FIELD SERVICE BULLETIN

FIELD SERVICE BULLETIN NO. 22
15 NOVEMBER 1954

SUBJECT: INSPECTION AND/OR REPAIR OF CRACKS IN FUSELAGE
FRAME 143-31004-16 AT STATION 294. 1

EFFECTIVITY: ALL NAVION AIRCRAFT (MANDATORY)

FIG. 1
LOOKING FWD

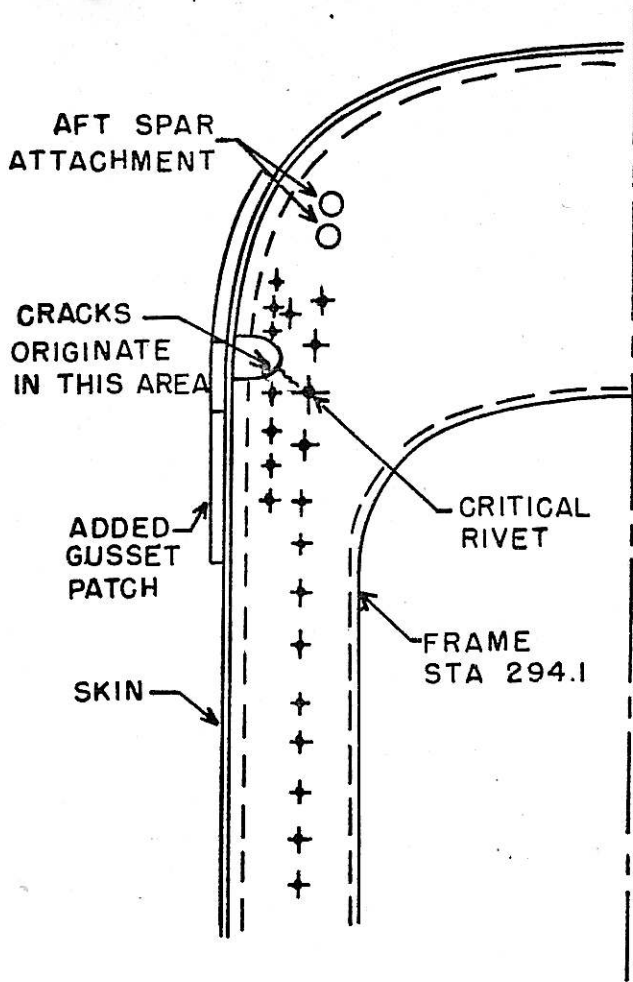
1. Inspection of some Navion aircraft has revealed that cracks may exist in fuselage frame 143-31004-16 at Station 294. 1 inboard from the top stringer cutouts at W. L. 21. 00. Immediate inspection of the area must be made by removing the inspection plate on the left side of the fuselage beneath the horizontal stabilizer, looking forward to view the aft side of frame at points in question. If no crack is visible, perform a thorough inspection of the frame at each 100 hour inspection thereafter.

2. If a crack is visible at either side of the frame, determine if it has extended beyond the critical rivet (see Figure 1) if so, it is necessary to apply paragraph 3, otherwise proceed as follows immediately.

- a. Remove stabilizer for access to bulkhead.
 - b. When crack extends to the critical rivet, remove the rivet and relocate nearby or if cracks does not extend as far as the critical rivet, stop-drill end of crack.

- d. Reinstall stabilizer.
 - e. Check cracked area at each 100 hour inspection to determine if crack has extended beyond critical rivet. If so it will be necessary to apply paragraph 3.
